PUBLIC HEARING MEMORANDUM

SUBJECT: Petition #176-19, for a SPECIAL PERMIT/SITE PLAN APPROVAL to further extend a

1188 Chestnut Street

Re: Special Permit – 1188 Chestnut Street

B. Site Design

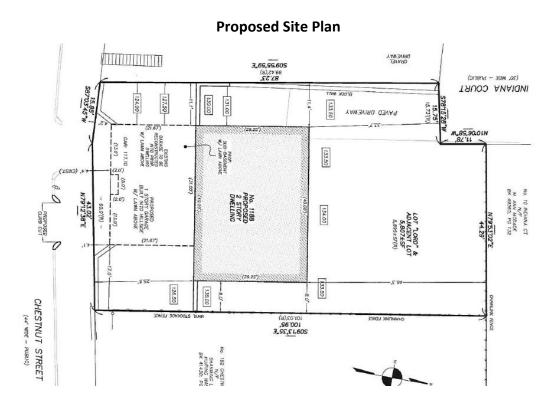
The petitioners are proposing to extend the garage to the east by approximately 18 feet to allow for a second garage bay. Due to the bend in the street, the front setback will be reduced from 4.4 feet to 4.1 feet. There is a utility pole along the site's frontage that will require the petitioner to install a second curb cut to provide access to the second garage bay. This additional curb cut will render much of the frontage a driveway opening. The remaining frontage, approximately 33 feet, will be improved with retaining walls that sit directly behind the sidewalk. The site will be terraced such that the roof of the garage will be a "green roof" that will serve as open space. This level area also contains retaining walls in the form of planters. The petitioner should confirm that these planters are not four feet in height because of their location within the front setback. The petitioner is not proposing any changes to the lawn area at the rear of the site.

The Planning Department believes that the extended nonconforming front setback will create a safety concern. The property is located on a bend in the street that, when combined with the short distance from the sidewalk, will result in limited visibility for vehicles backing out of the site onto Chestnut Street. The Planning Department recognizes that this condition exists with the existing one-car garage but believes that

the condition should not be increased with an additional parking stall.

Staff also recognizes that the property at 1186 Chestnut Street features a two-car garage close to the street and features a similar topographical condition. These two properties are outliers when compared with other properties in the immediate area due to their location along Chestnut Street and to their slope. However, the subject property is different from the property at 1188 Chestnut Street because the subject property has a large area at the rear of the site, close to Indiana Court, which may allow for parking, and the current vacant site allows for design flexibility. The Planning Department does not believe that the topographical condition should result in a safety concern and suggests that the petitioners consider alternatives for parking on site, including providing access from Indiana Court.
